April 25, 2025

Blue Jay Point County Park - Renovation Wake County

ADDENDUM #3

L169

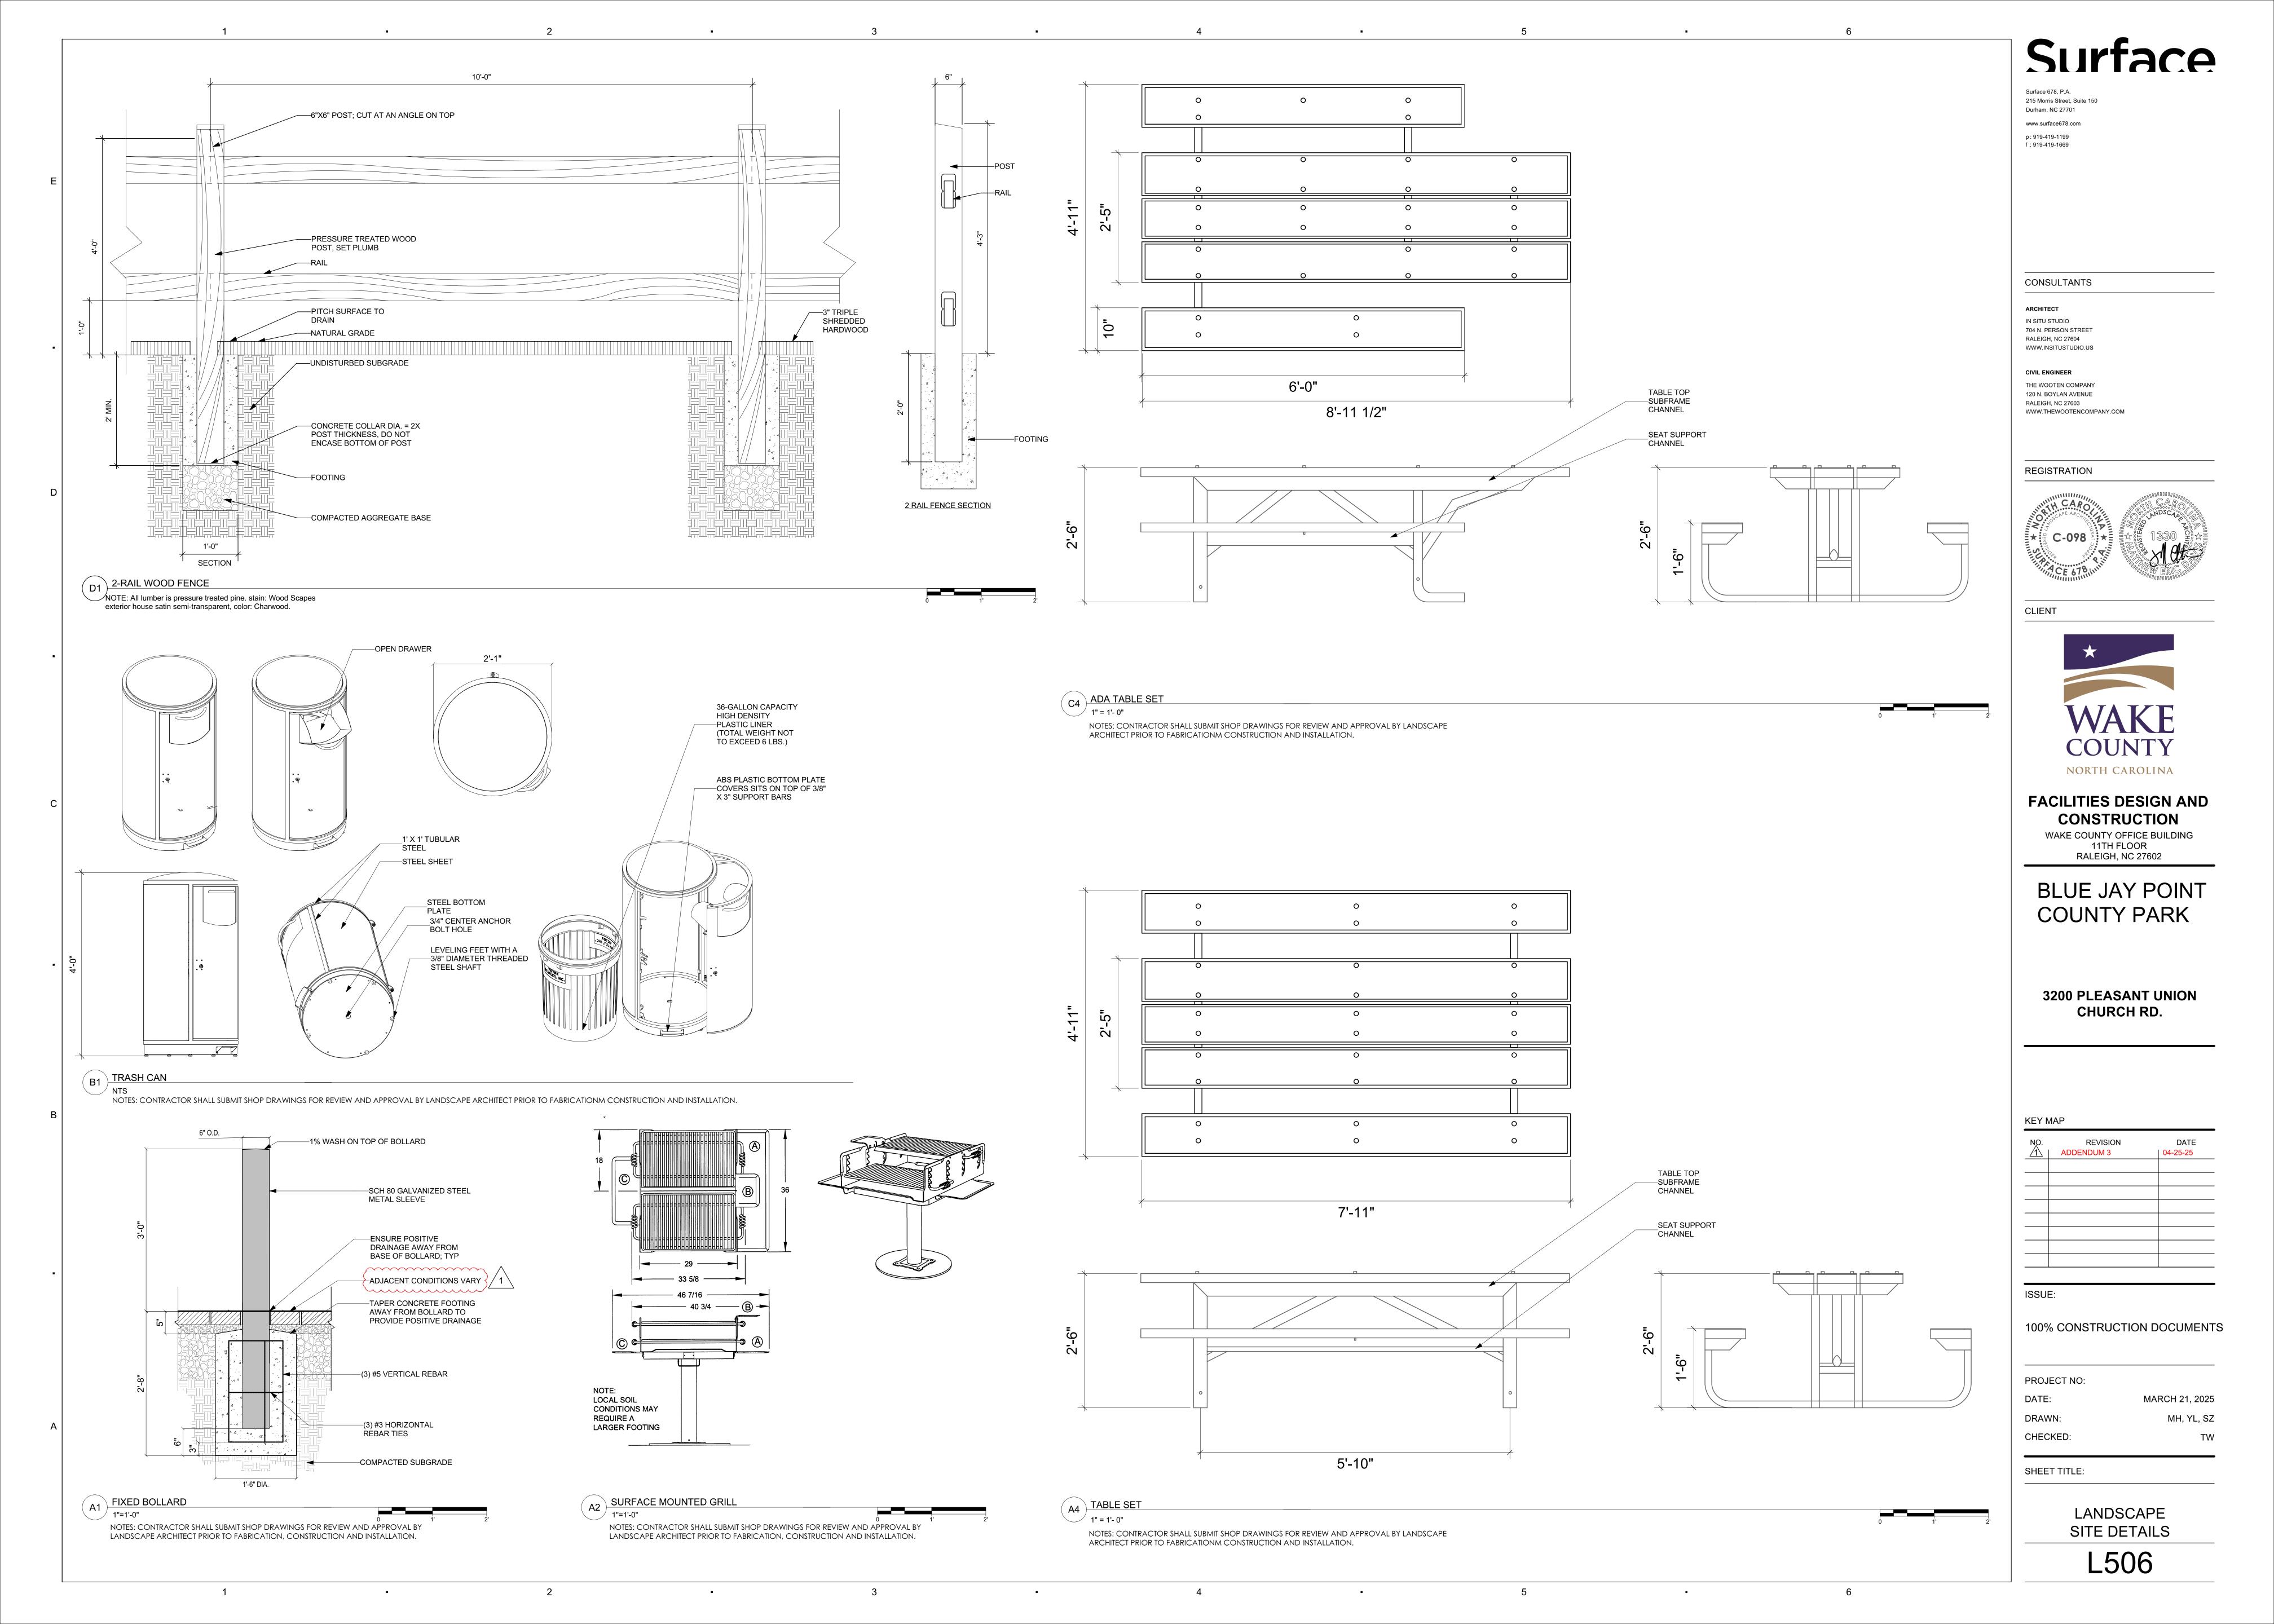
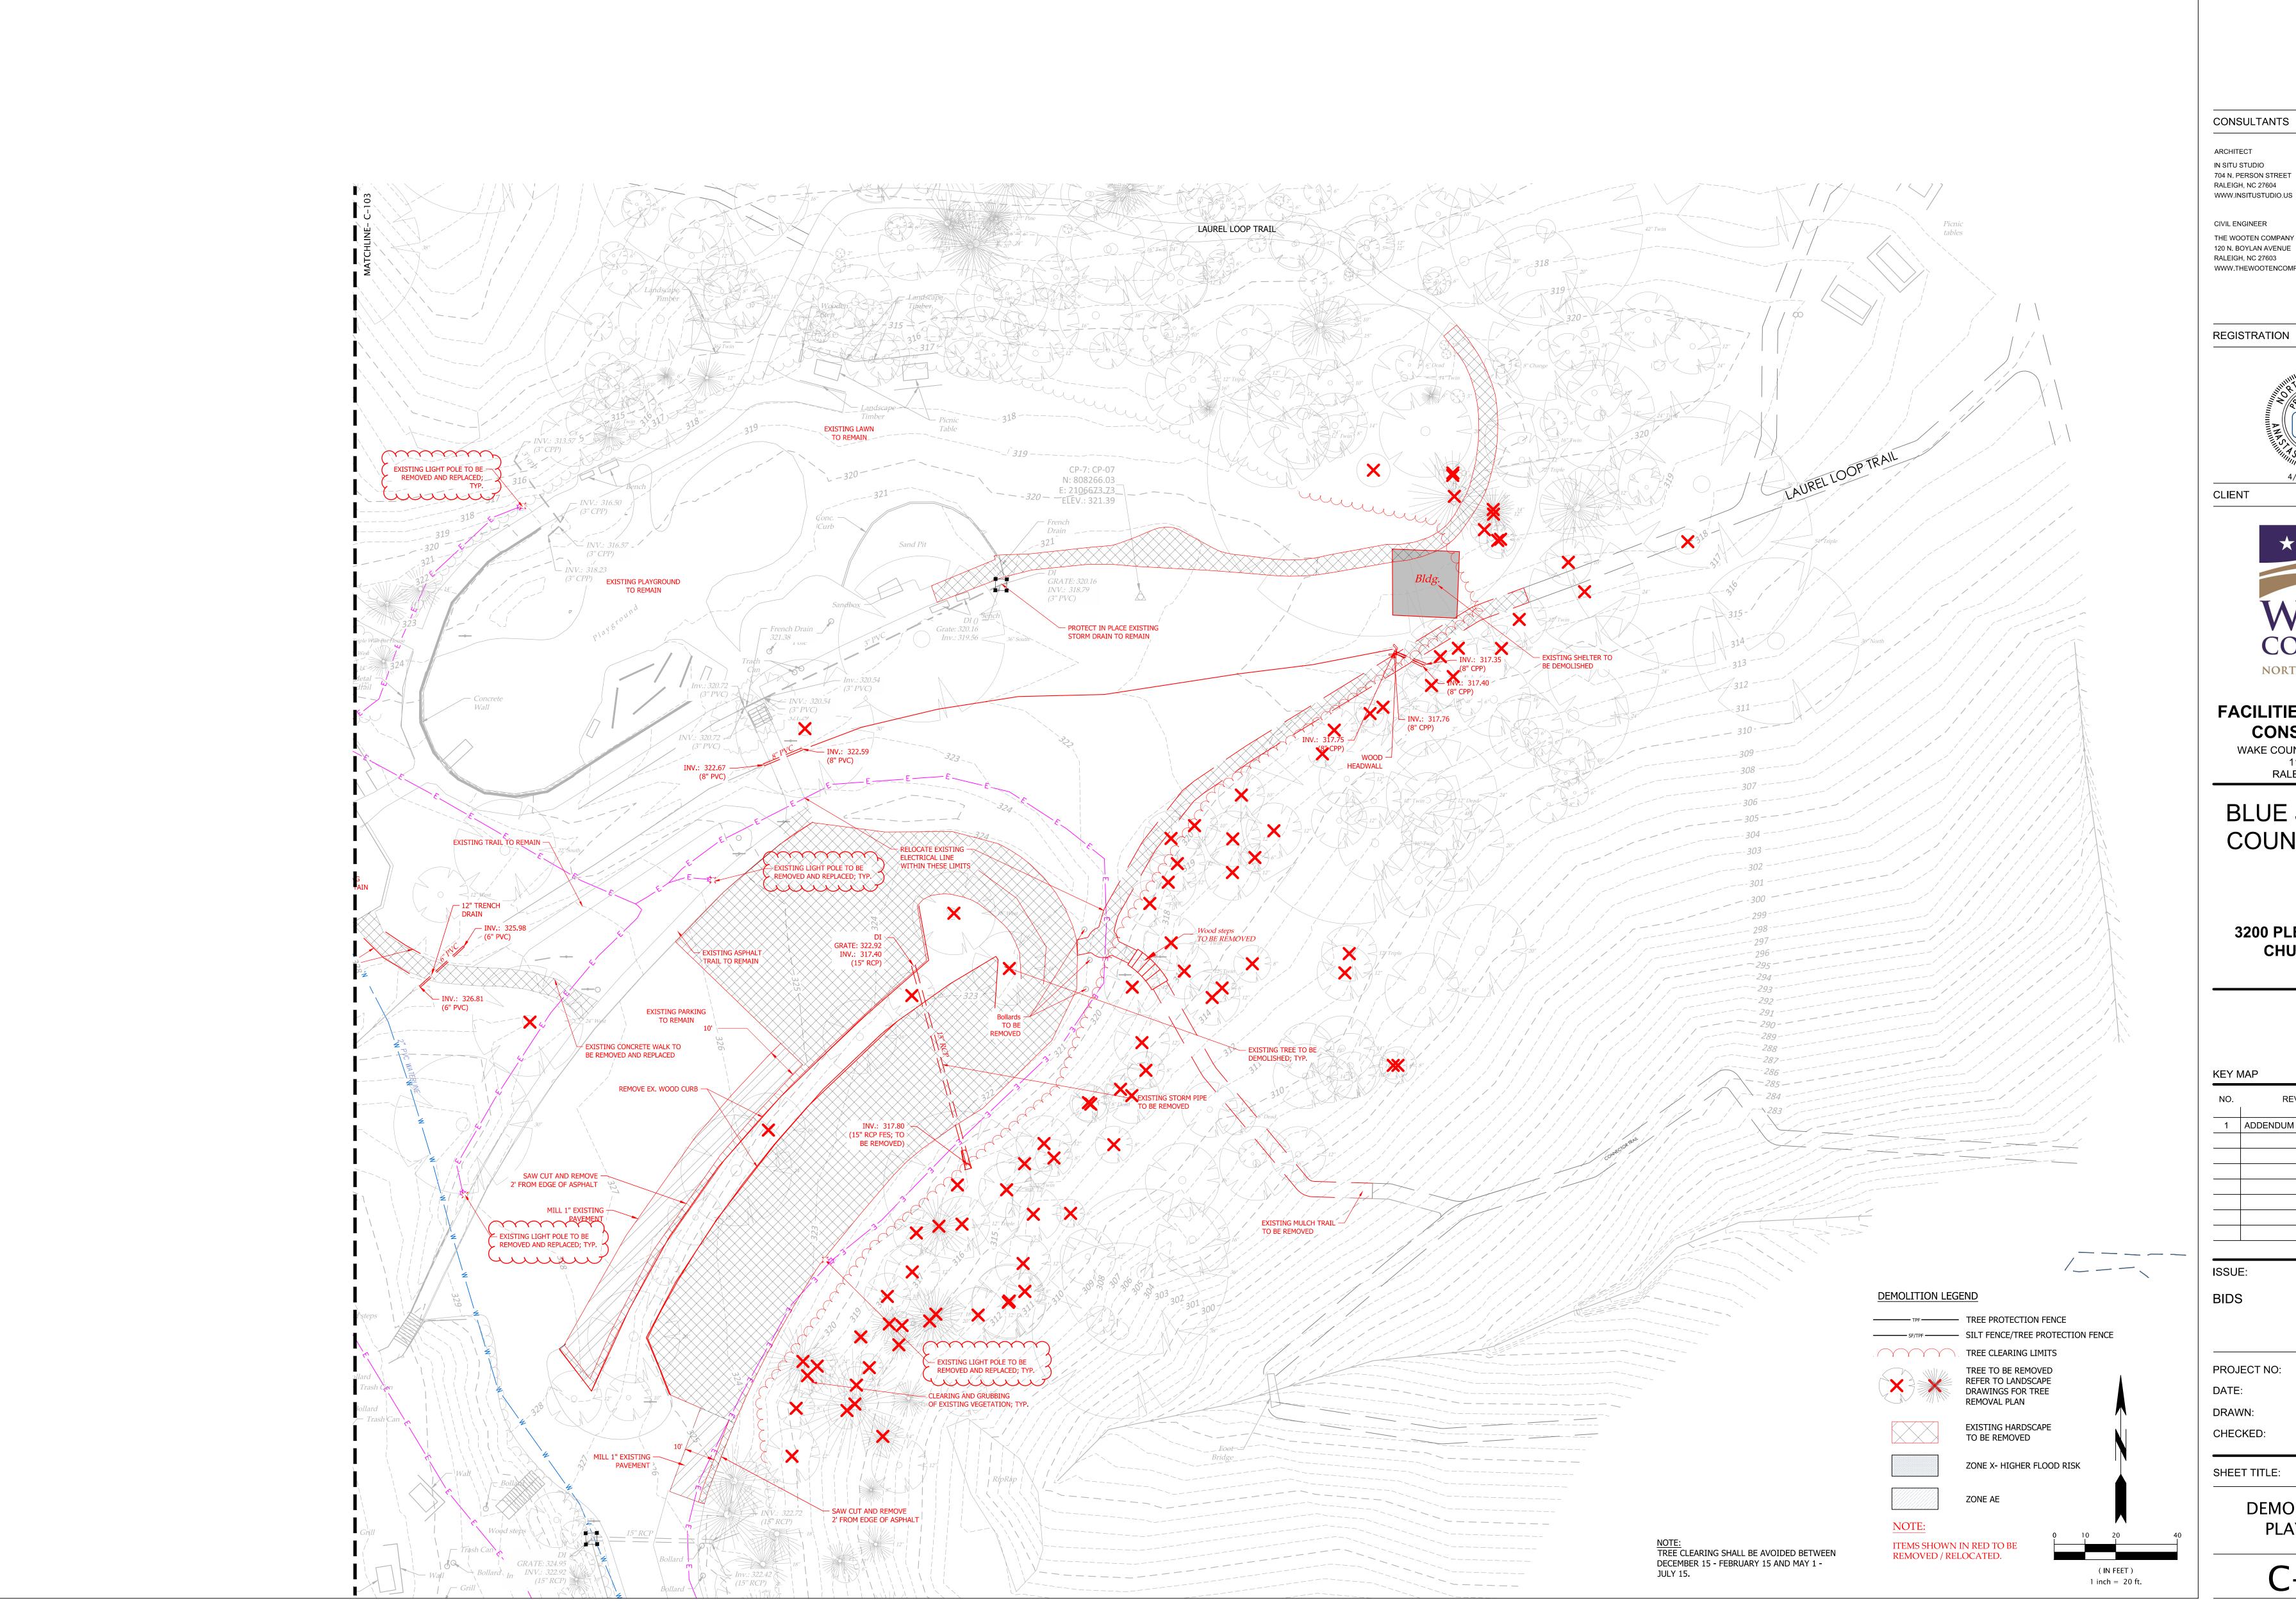
- I received a question regarding sod. Spec section 329200-2.2.B specified TifTuf
 Bermudagrass or Tiffway 417, however the landscape planting drawings sheets appear to
 specify Fescue sod in the planting legends. Seed is also specified as Fescue or Bermuda.
 Please confirm which grass type is desired.
 - a. Response: Wake County Parks prefer Bermuda grass, Specification 329200 Turf and Grasses. Planting legends revised on planting sheets.
- 2. Question regarding mulch. Take sheet L161 for instance, this sheet shows a large area being covered with mulch. Is that intended to be the triple shredded hardwood per the specs? A pine straw mulch? Or a seed/straw mulch (at areas greater than 4:1 slope)?
 - a. Response: Per specification 329300 Plants 2.6 Mulch, A. Mulch, 1. Type: Triple shredded hardwood. An area of engineered wood fiber has been added in the
